DEVIATION REVIEW AND DECISION FORM

Legal Description of Property: TR IN E2 SEC 29-13-65 DESC AS FOLS: COM AT NE COR OF SD SEC, TH S 89<10'57" W 2105.32 FT, S 04<23'18" W 3857.57 FT TO POB, TH CONT ON SD LN 1456.87 FT, N 89<19'38" E 1240.25 FT, N 00<02'55" E 1451.73 FT, S 89<18'20" W 1391.65 FT TO POB, EX PT PLATTED TO N CAREFREE CIR, EX THAT PT CONV BY REC #206084137
Subdivision or Project Name: Gardens at North Carefree

Proposed Nature and Extent of Deviation: The proposed deviation is to allow a 45-foot right-of-way for the proposed Urban Local subdivision streets by eliminating the 2.5-foot strip between the back of sidewalk and the ROW line on each side (5' total). The ROW line would be at the back of sidewalk on each side. No other modifications to the standard cross section shown in ECM Figure 2-16 are proposed.

1 **TYPICAL SECTION - PUBLIC STREET**
 SCALE: NTS (URBAN LOCAL)

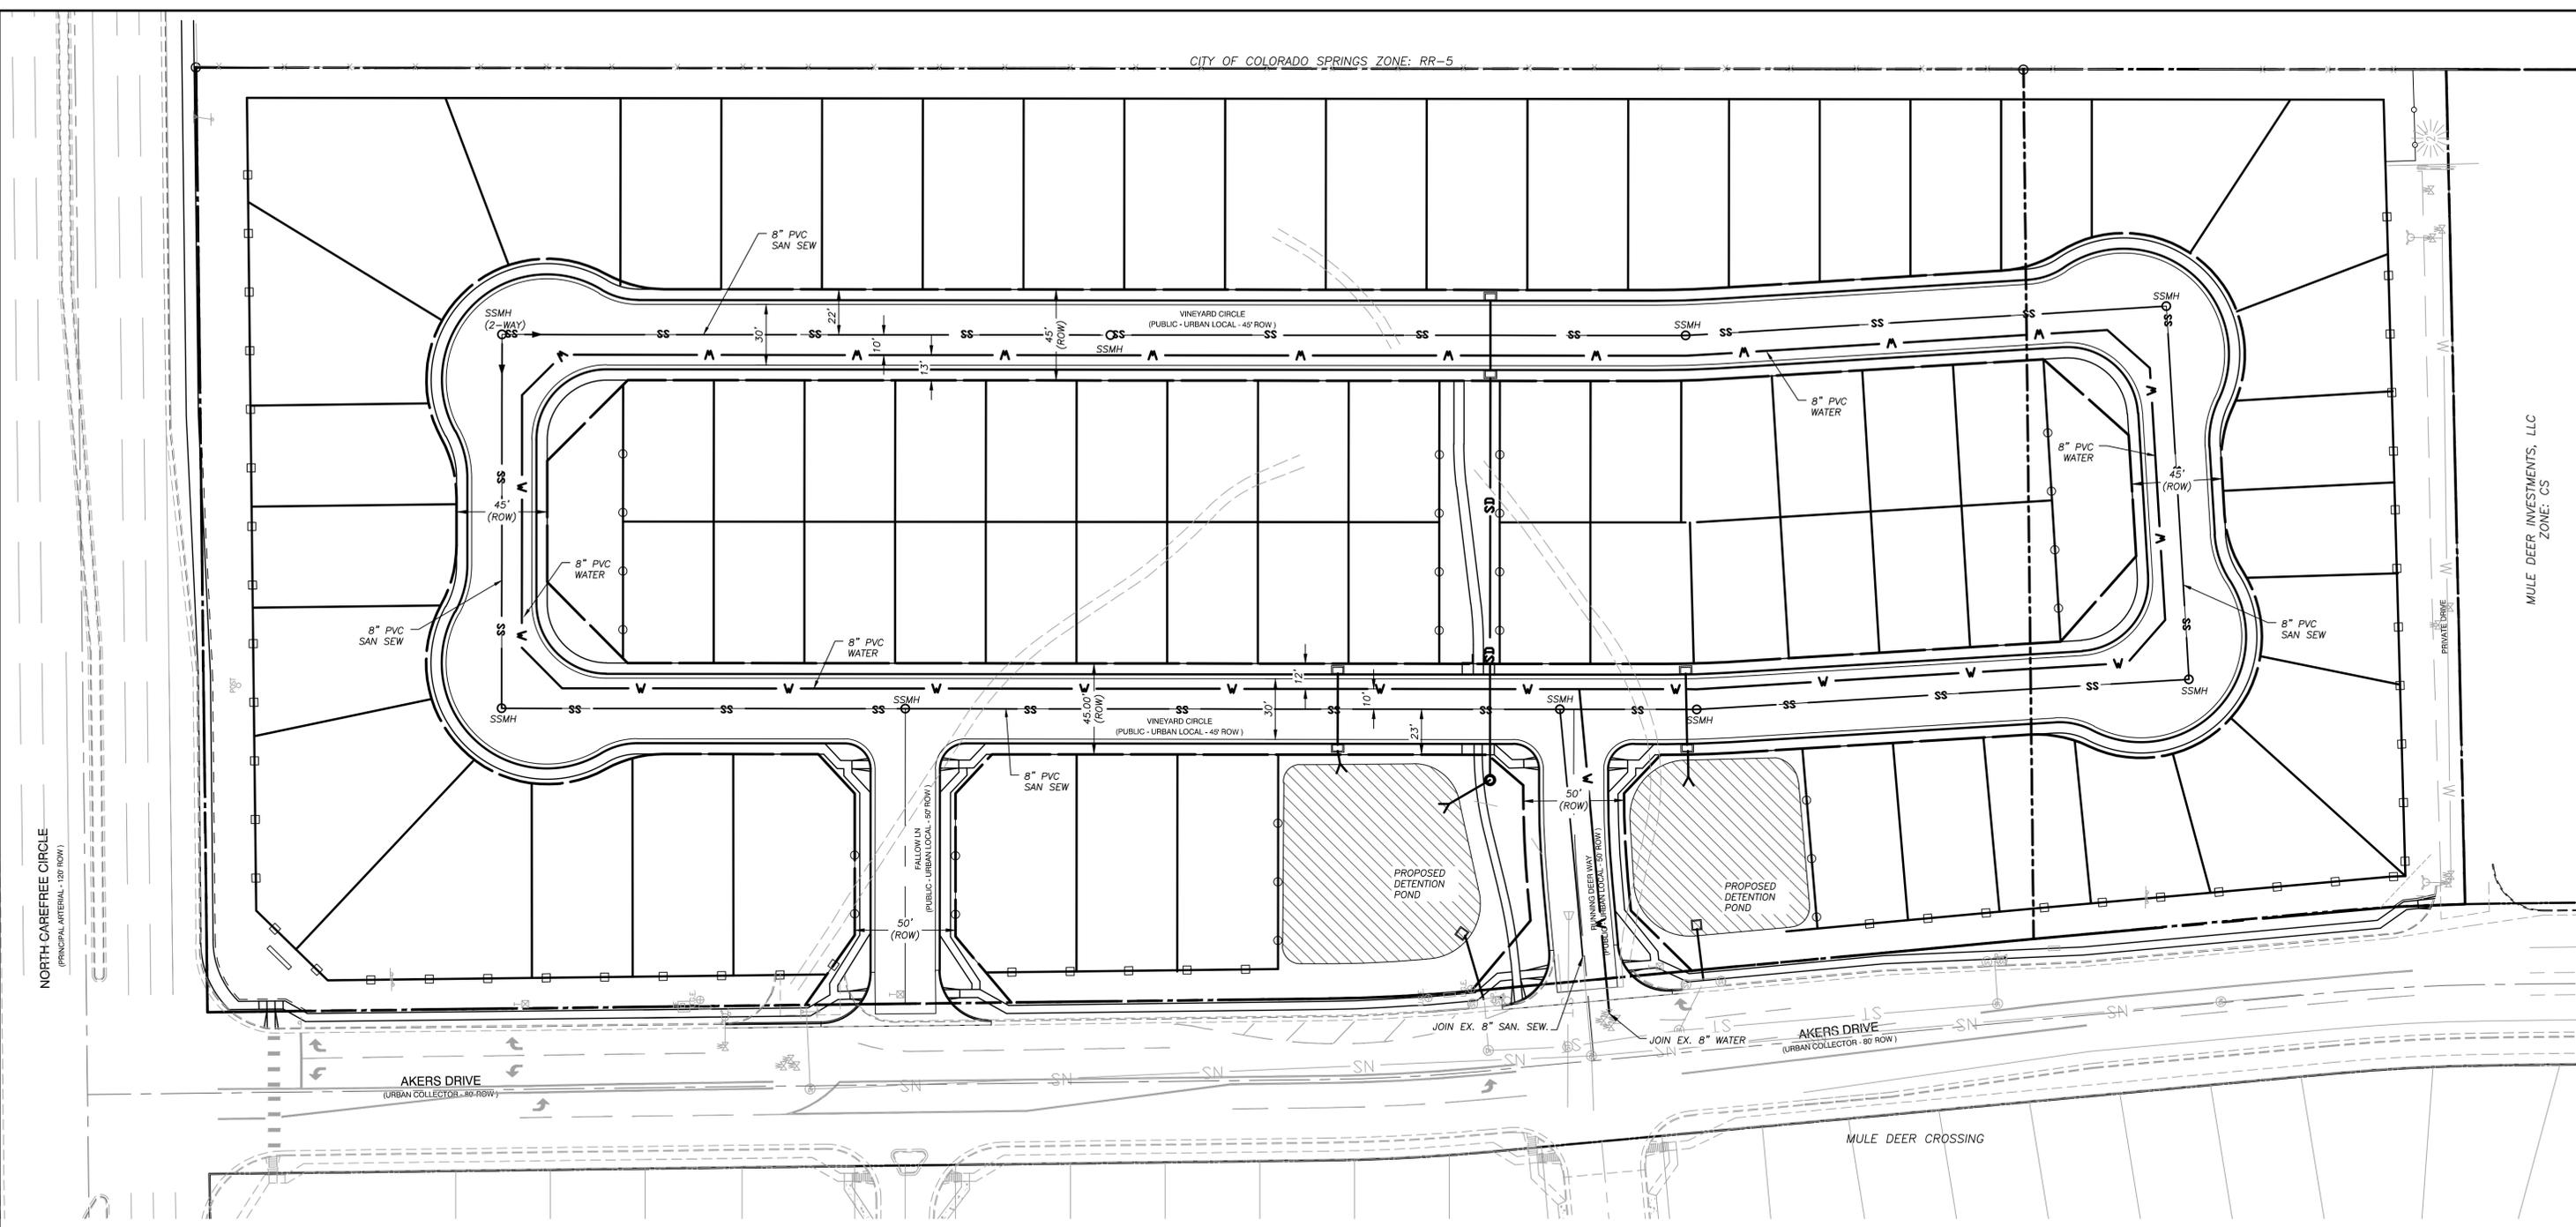
Reason for the Requested Deviation: The primary reason for this deviation is to accommodate the prescribed ECM intersection centerline spacing along Running Deer Way. The deviation will allow a shift in the lots to the east to meet the 175-foot ECM-prescribed intersection centerline spacing. Also, the deviation will allow the site to accommodate the lots and open space given that the site is narrower on the south side.

Comparison of Proposed Deviation to ECM Standard: The proposed deviation is to allow a 45-foot ROW instead of the standard 50-foot ROW for the proposed subdivision streets. The only difference from the ECM-standard cross section would be the elimination of the 2.5-foot-wide strip between the back of sidewalk and the ROW line on each side (5' total). The ROW line would be at the back of sidewalk on each side. No other modifications to the standard cross section shown in ECM Figure 2-16 are proposed.

The deviation would result in a comparable design. The streetscape corridor will be 5' less than the standard. However, this will be consistent with the density and design of the subdivision. Sidewalk maintenance will not be impacted with the

The deviation will not adversely affect safety or operations. Safety and operations will not be negatively affected by this deviation. The narrowing of the streetscape corridor, although minor (5-feet) in this case, has the potential (in general) to actually encourage slower vehicles speeds along the Local street.

The deviation will not adversely affect maintenance and its associated cost. Sidewalk maintenance will not be impacted with the removal of the 2.5 feet behind the sidewalks because there will still be a 5-foot public improvements easement adjacent to the back-of-sidewalk on each side.

**Review and Recommendation:
APPROVED by the ECM Administrator**

This request has been determined to have met the criteria for approval. A deviation from Section 2.3.2 and 2.3.4 of ECM is hereby granted based on the justification provided. Comments:
Limited to Vineyard Circle only.
